STAFF RECOMMENDATION 1406 Fifth Avenue North June 15, 2016

Application: New construction—addition, reconstruction, outbuilding (detached accessory dwelling unit)

District: Germantown Historic Preservation Zoning Overlay

Description of Project: Application is to reconstruct a front porch and construct a side porch and outbuilding that includes a detached accessory dwelling unit.

WEST ELEVATION - GARAGE

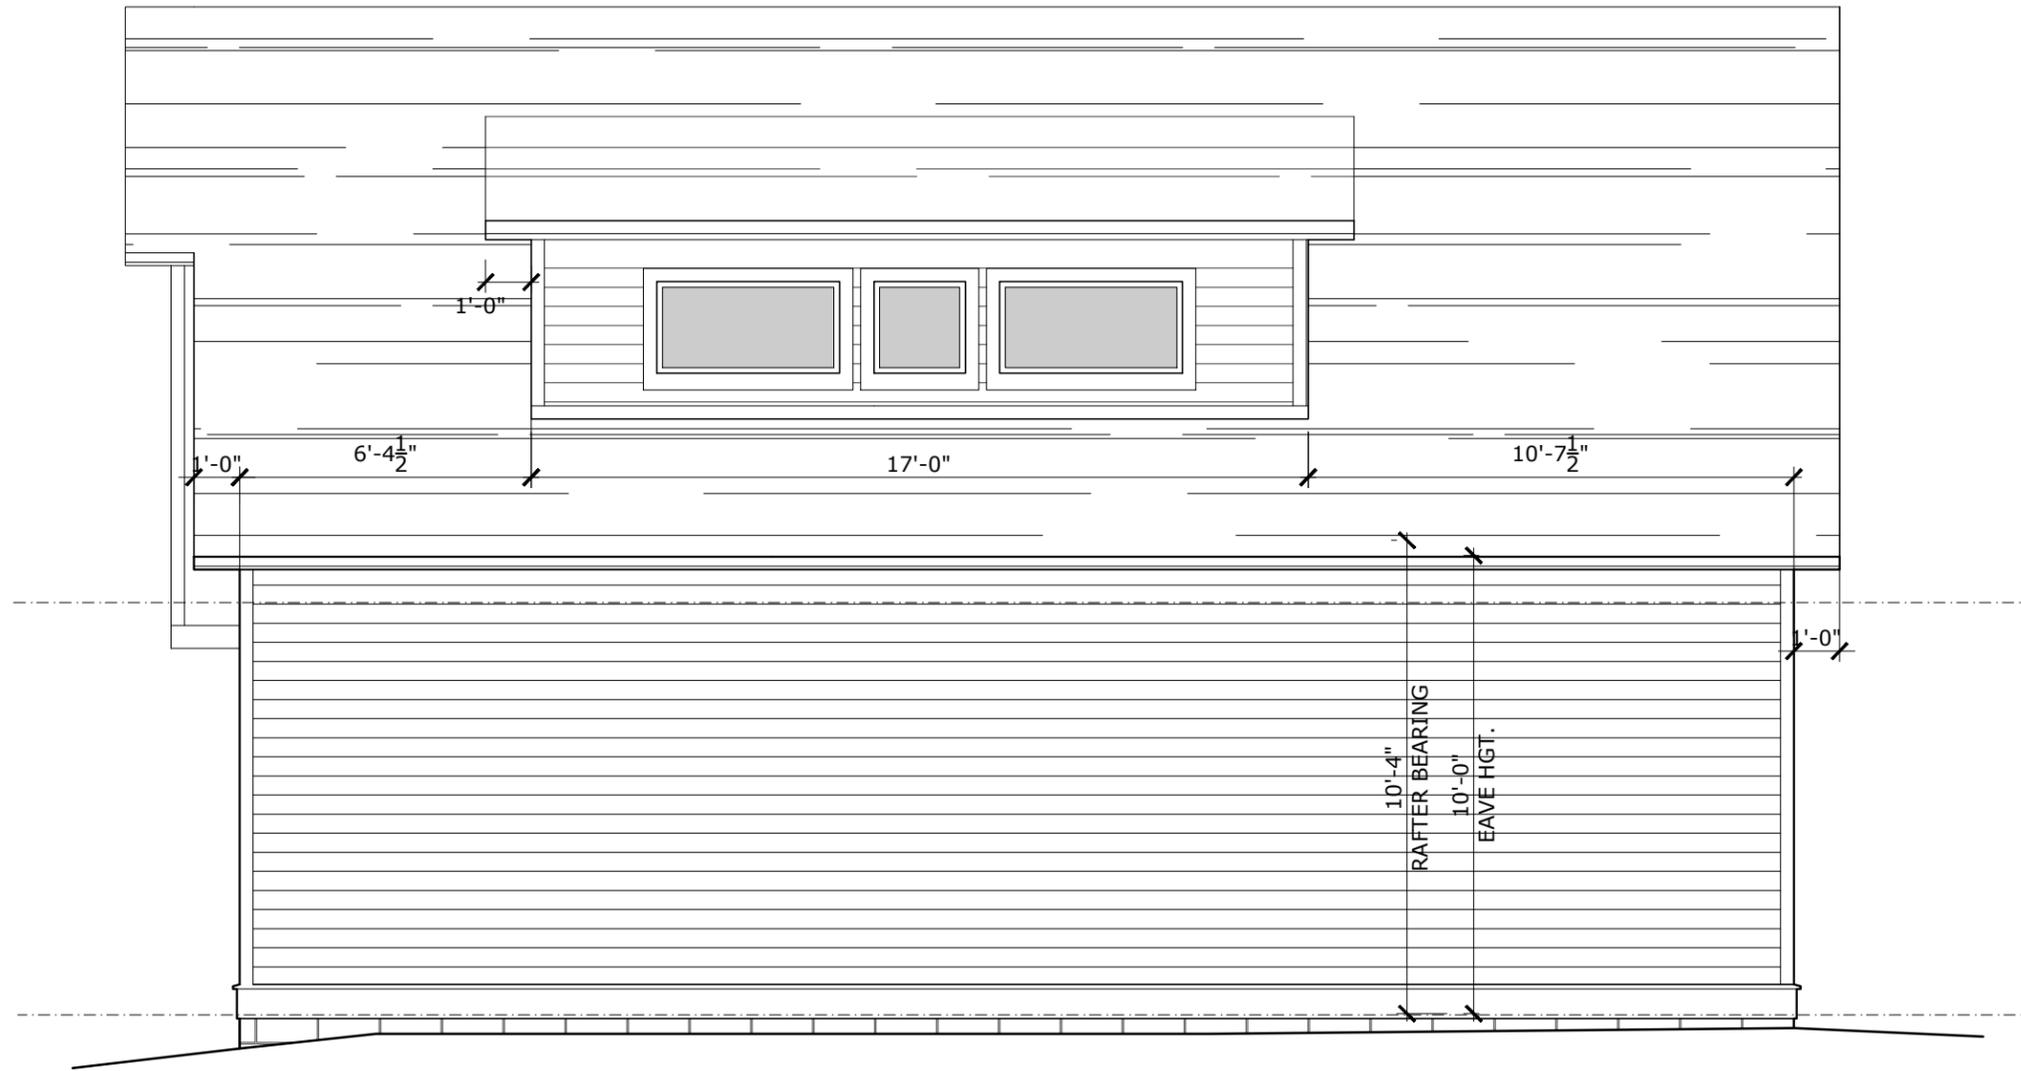
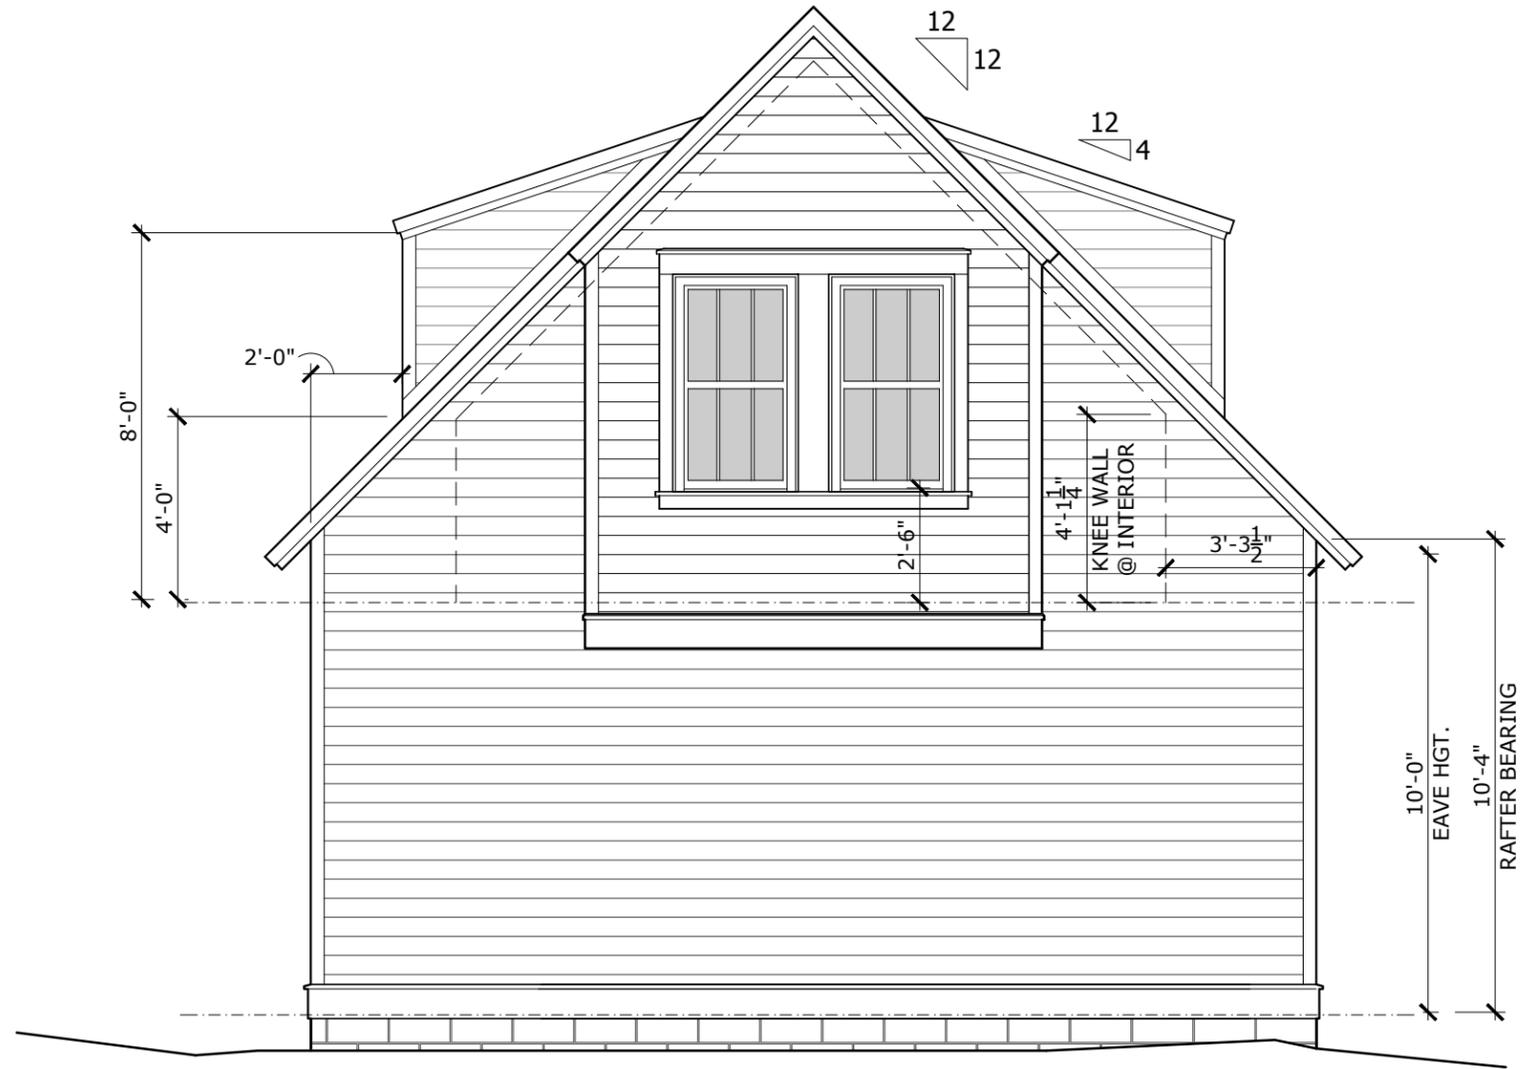
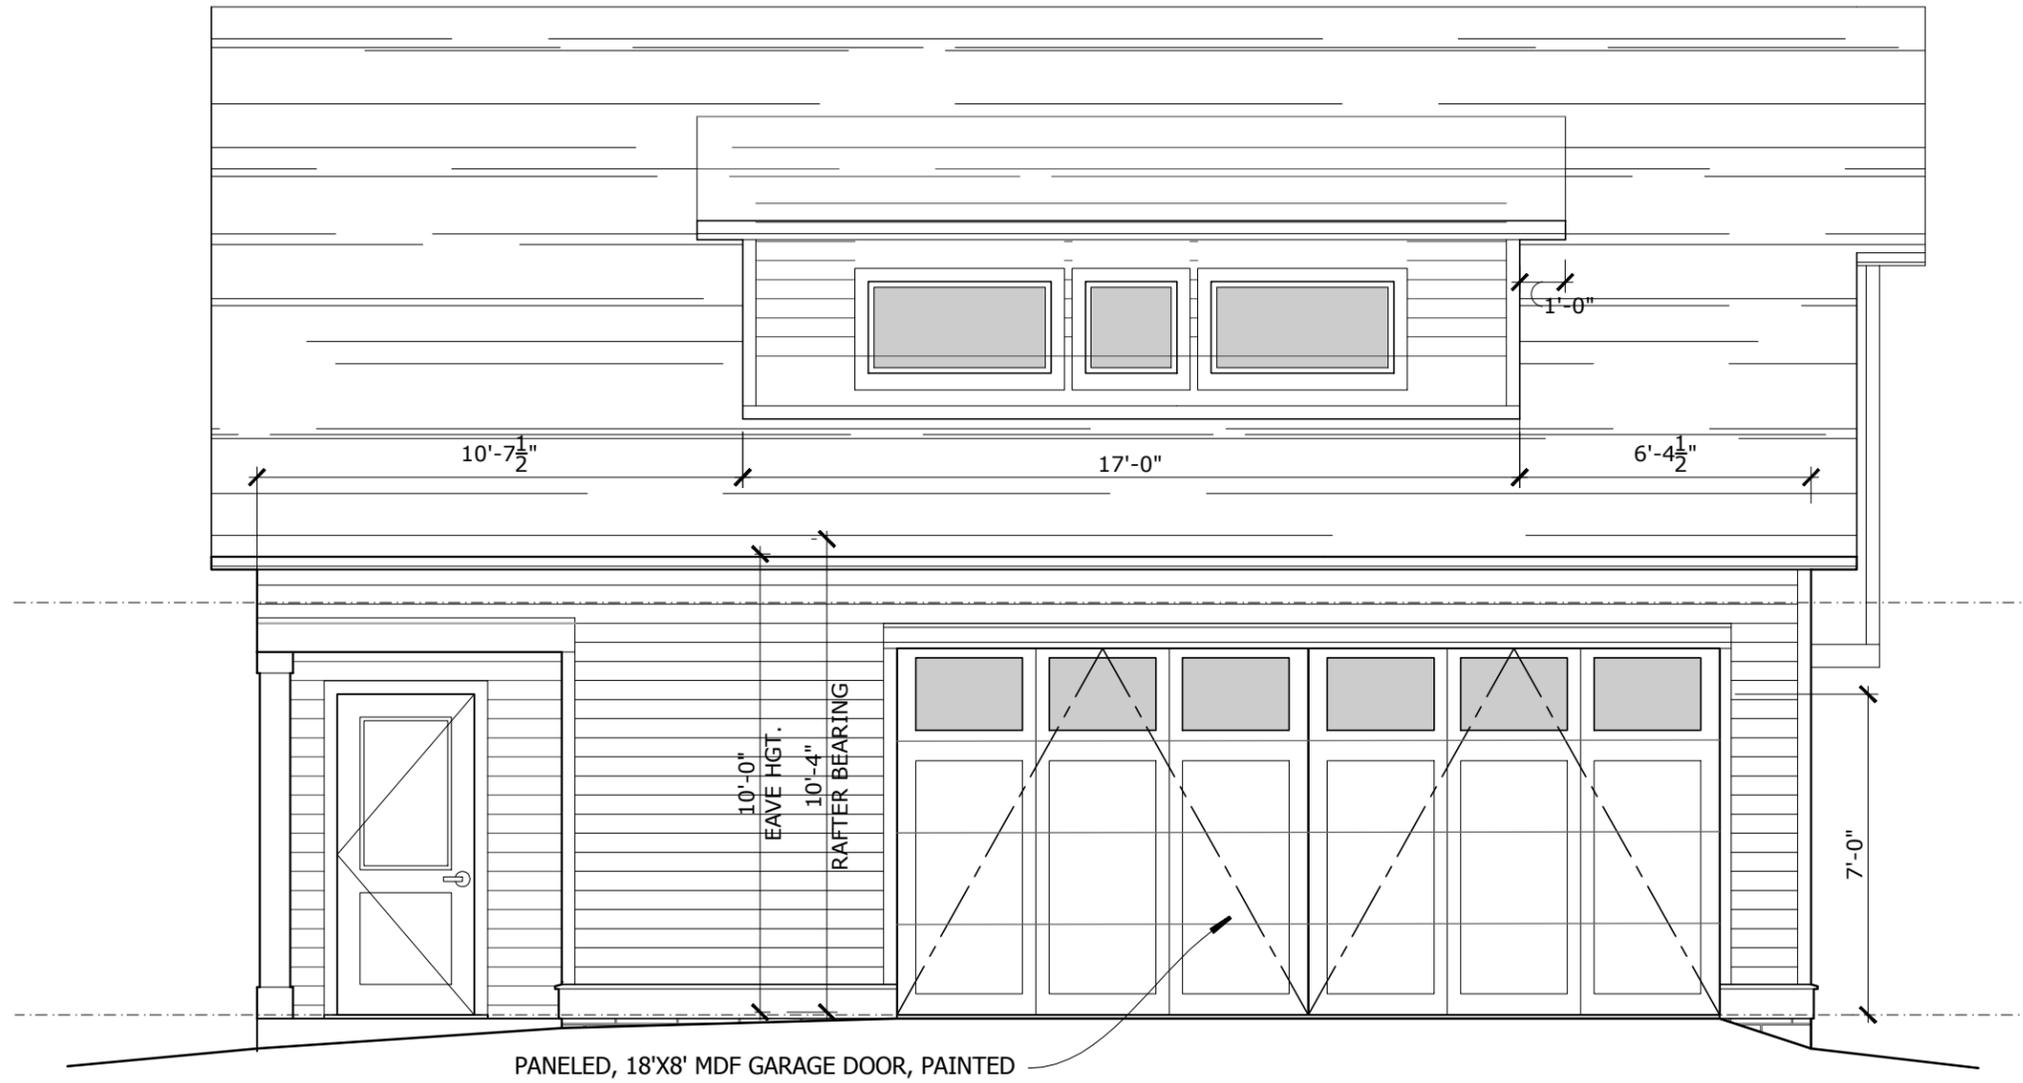
Proposed Element	Proposed Form	Typical of district?
Primary form	Gable – front oriented	X
Primary roof pitch	12:12	X
Porch form	Under roof	X
Porch roof pitch	n/a	n/a
Dormers	Shed – 4:12	X

Since the form and roof pitch are similar to historic outbuildings, the project meets Section 2.9.4 of the design guidelines.

Design Standards: The accessory structure has a simple, utilitarian design that is appropriate for outbuildings. Its roof form, detailing, and form do not contrast greatly with the primary structure. It is also in a minimally-visible location at the side and rear of the building. The structure therefore meets Standard 8 of the Detached Accessory Dwelling Unit regulations and Section 2.9 of the design guidelines.

Proposed	Color/Texture	Approved Previously or Typical of Neighborhood
Foundation	Concrete slab	Natural color	X
Cladding	Cement-fiber	Smooth with 5” reveal	X
Roofing	Asphalt shingle	Dimensional, Graphite color	X
Trim	Cement fiber	Smooth finish	X
Chimney	n/a	n/a	n/a

Porch floor	Concrete slab	natural	X
Porch Columns	Wood	Smooth finish	X
Porch Railing	n/a	n/a	n/a
Windows	Needs final approval	Needs final approval	
Pedestrian Door	Not indicated	Needs final approval	
Vehicular Door	Not indicated	Needs final approval	
Driveway	Not indicated	Needs final approval

1. Staff shall approve the window and door selections, as well as paving, fences and other permanent landscape features;
2. Staff approve all permanent landscape features, included but not limited to fences, pathways, pavers, parking pads, pools, etc.
